Index 649-020 Steel CCTV Pole

STEEL CCTV POLE

INDEX
649-020

SHEET
3 of 6

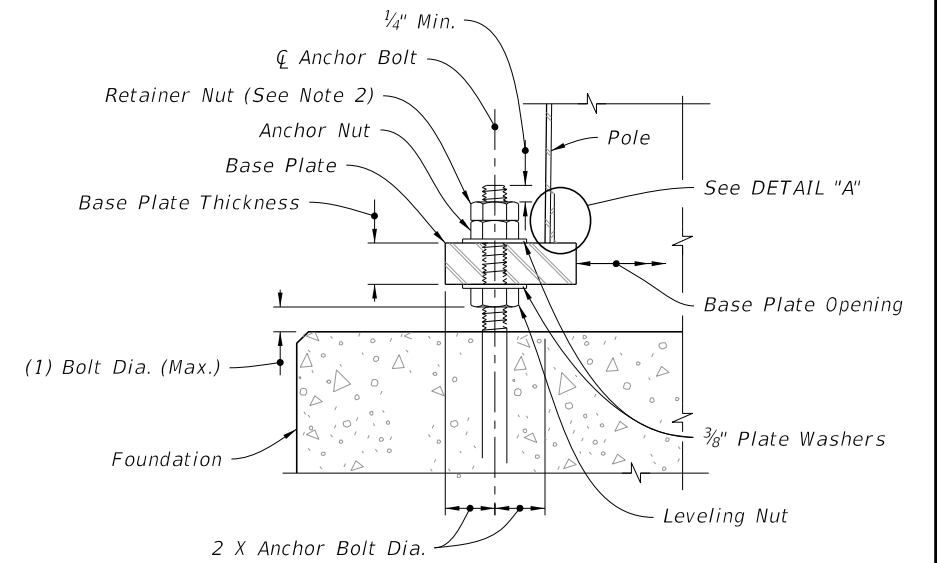
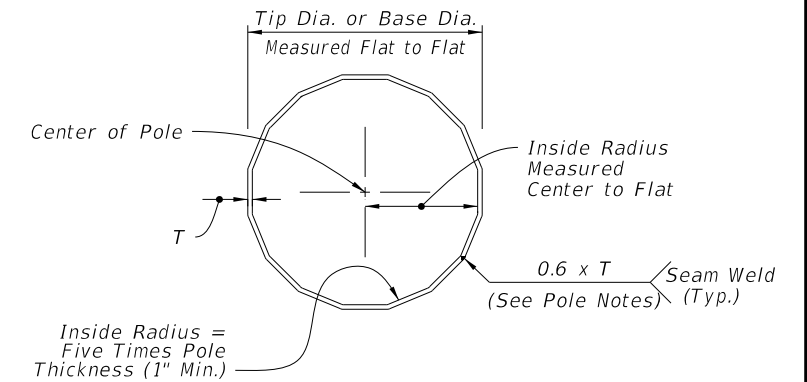
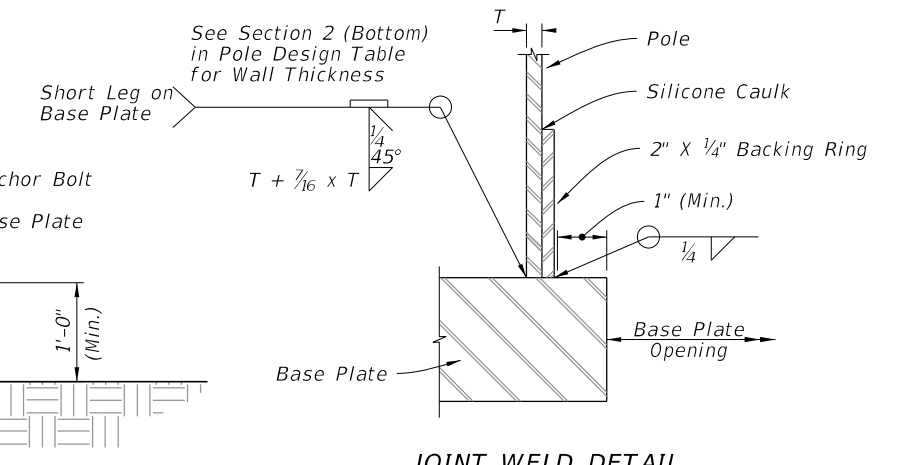
Sheet 3: Anchor nut labels were adjusted to correspond correctly with upcoming associated Spec change being drafted for Section 649; We corrected weld detailing for clarity and brevity.

COMMENT: See comments on 649-010 for base plate weld symbol correction. Silicone-caulk call out is not in agreement with 649-010. I think the detail in 649-010 is more preferable. We cannot have CJP welds without either one of the following: backing bar, back welding, backing weld, or melt through (melt through is probably the only feasible option). This needs to be fixed."

RESPONSE: Good catch. We will update that callout and make the same adjustments as 649-010.

CHANGE MADE TO INDEX: Updated Sheet 3 to remove dimensions and update callouts.
